Access Compliance Report Public Rights-of-Way (Curb Ramps)

Intersection ID: 53633 Main Street: TREMONT RIDGE CT Cross Street: BEACON VALLEY ST Location: NE **Overall Compliance: No Severity Score:** 25 ADA ID: C682E8818792 Ramp Type: Perp Initial Pass/Fail: Fail

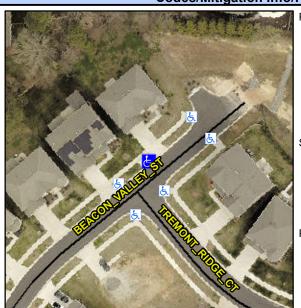
BEACON VALLEY ST Street 1 Name Stop Condition-Street 2 None N/A Street 2 Name Stop Condition-Street 1 N/A Possible Solutions: Compliance Description N/A Remove & Replace Entire Ramp. Surveyor Notes: N/A PROW/ADA: Not Found, R304.5.3

No Ramp XSlope (%) Yes Ramp Width (in) 59.0 N/A N/A Flare Type LT N/A Flare Type RT N/A N/A N/A Flare Slope RT (%) Flare Slope LT (%) N/A Flare Traversable LT? N/A N/A Flare Traversable RT? N/A N/A N/A **DWS Provided?** Landing Length (in) N/A Landing Width (in) N/A N/A **DWS Contrast?** N/A N/A N/A Landing Slope (%) DWS Length (in) N/A Landing X Slope (%) N/A N/A DWS Full Width? N/A Landing Curb? (Y/N) N/A N/A DWS Offset (in) N/A N/A Shared Landing? N/A **Gutter Ponding?** N/A N/A Gutter Slope (%) N/A Gutter Lip Ht (in) N/A N/A Gutter X Slope (%) N/A Painted X Walk1? No N/A Painted X Walk2? X Walk 1 Direction To SE X Walk 2 Direction N/A N/A X Walk 1 Width (in) X Walk 2 Width (in) X Walk 1 Slope (%) 0.1 X Walk 2 Slope (%) X Walk 1 X Slope (%) 9.0 X Walk 2 X Slope (%) N/A N/A N/A Ramp inside XWalk2? Ramp inside XWalk1? Road Slope (%) N/A N/A Clear Space? N/A Road X Slope (%) N/A Clear Space to XWalk (in) N/A N/A Any Obstructions? N/A Storm Grate/Utility Hazard? **Obstruction Type** Storm Grate/Utility Type
